HELIOS RENEWABLE
ENERGY
PROJECT

PINS Document Number:
EN010140/APP/6.3.8.10

**Environmental Statement
Appendix 8.10:
Consultation Record**

June 2024

Figure 1: Site Location Plan

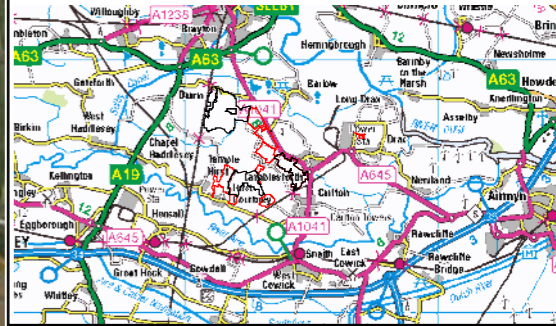
The Scoping Report, Table 8.2, suggests there may be a medium impact on foraging/commuting bats and so this should be considered when addressing surveys related to foraging/commuting. Additionally, the site plan, provided as Figure 1 in the Discretionary Advice Service application suggests works will take place between woodland and the water body, and between other wooded areas in the wider landscape, which may lead to commuting and foraging of bats being disrupted.
